# Access Compliance Report

## Public Rights-of-Way

Intersection ID: 28770	Main Street: BALDWIN_HALL_DR	Cross Street: GEORGIAN_HALL_DR	Location: NW
ADA ID: CB190A32E2BC	Ramp Type: BlendTrans1	Initial Pass/Fail: Pass	Overall Compliance: No
Severity Score: 22.75			
Codes/Mitigation Info/Possible Solution		Field Measurements/Component Compliance

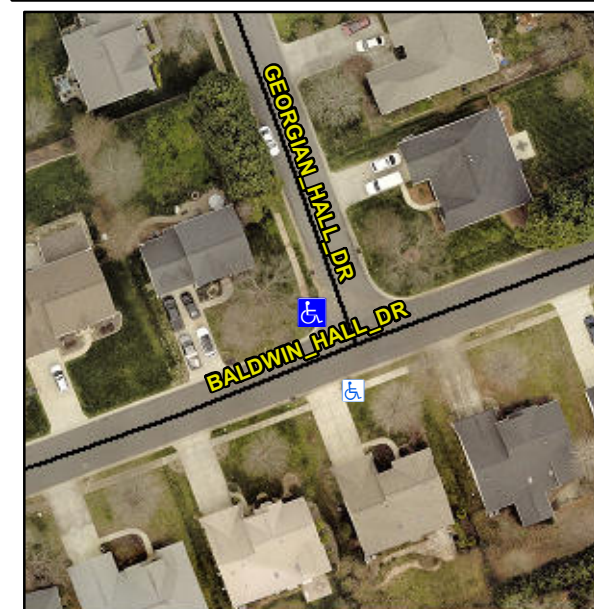
**Remove & Replace Curb Ramp With Two New Directional Ramps or Equivalent. Remove & Replace Gutter.**

**Not Found, R305, R302.7.2, R304.5.4**
